Figure 3.22: Baseline Surface Water flows at Stream locations north-east of the site

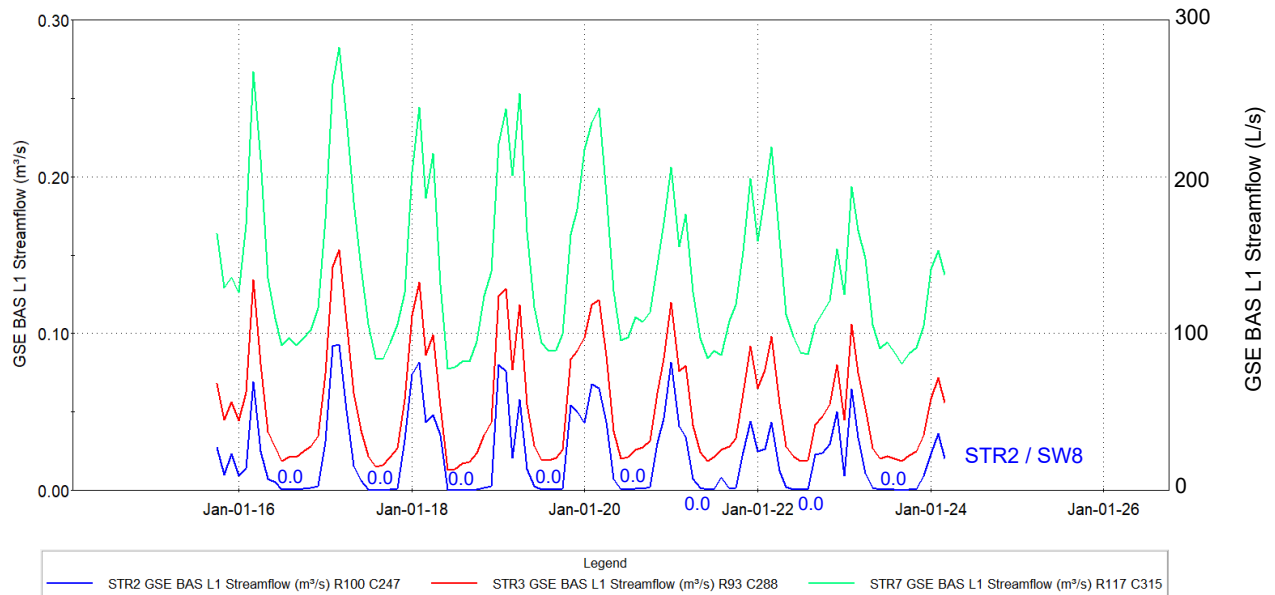
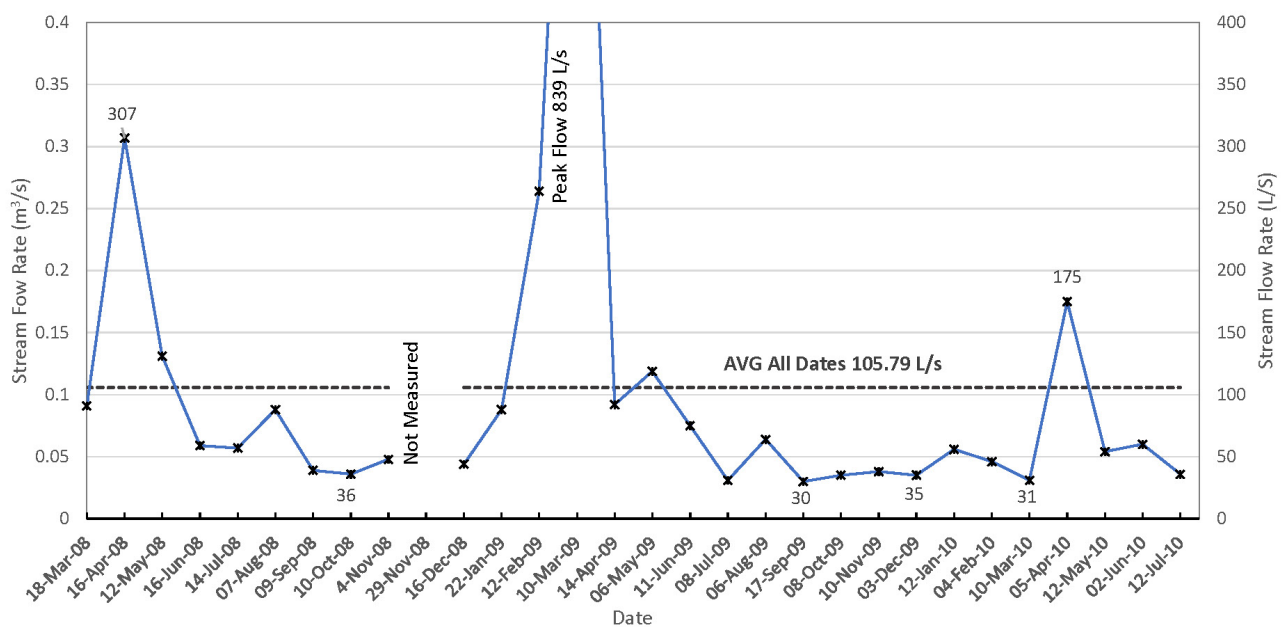
- 1) Genivar (2011) Table H-27 reported simulated Groundwater Discharge Rate at SW8/STR2 at 3,520 m³/day (40.7 L/s) and calculated observed low baseflow at 3,575 m³/day (41.4 L/s).
- 2) Newell / Funston Commercial Aquaculture (Fish Hatchery / Rearing Ponds) MECP Permit PTTW #7121-9Y7HP7 total is 741 m³/day (8.6 L/s) (Earthfx Aug 2024, pg D-102) immediately downstream of SW8/STR2.
- 3) Genivar DP-SW8 reported Mean Flow at 0.35 m³/sec (350 L/s) in Earthfx Aug 2024 Table 3.6, pg D-57 and Table 4.3, pg C-83 or in the source material. This flow is an obvious error.
- 4) Earthfx (August 2024) Fig 3.22 pg 37 Simulated Virtual Model Baseline Condition Dry Weather Flow at SW8/STR2 is at 0.0 L/s.

The Earthfx Model Calibration for Baseline Conditions is obviously not validated for assessment prediction purposes.
